VILLAGE OF DOWNERS GROVE
Report for the Village Council Meeting
5/9/2017

SUBJECT:	SUBMITTED BY:
Stormwater and Floodplain Ordinance Variance 4710 Highland Avenue	Nan Newlon Director of Public Works

SUBJECT: 4710 Highland Avenue – Petition for Variance

Figure 1 – 4710 Highland / LPDA SJ79

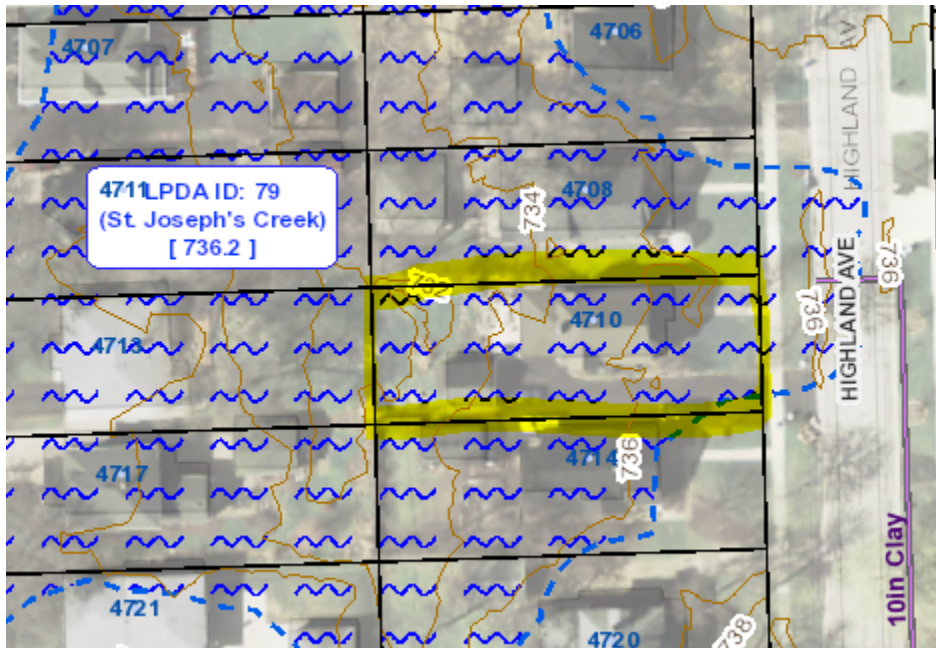
The homeowner applied for a permit to do the above work on September 15, 2016. Almost the entire lot, including the entire garage, is within LPDA SJ79, with a BFE of 736.2 (NAVD88), which would make the flood protection elevation (FPE) of 737.2 – see Figure 1. The existing driveway is shared with the neighbor to the south (4714 Highland Ave) – see Figure 2.

The homeowner's engineer submitted a site plan, which proposes a finished floor elevation of 734.4, which is 1.8 feet below the BFE. The plan proposes to move the garage to the north to meet the current 5' setback requirement. The elevation of the proposed garage is somewhat limited because of the shared driveway configuration. The plan provides compensatory storage for all fill within the LPDA (at a ratio of 1:1, as required by the Code). Flow through flood vents will be provided in accordance with FEMA TB-1 and Flood-Resistant Materials will be used per FEMA TB-2.

Staff recommends flood resistant materials be provided to an elevation of at least one foot above the BFE of 736.2, which would be a minimum of 737.2 or 2.8 feet above the proposed garage floor elevation of 734.4.
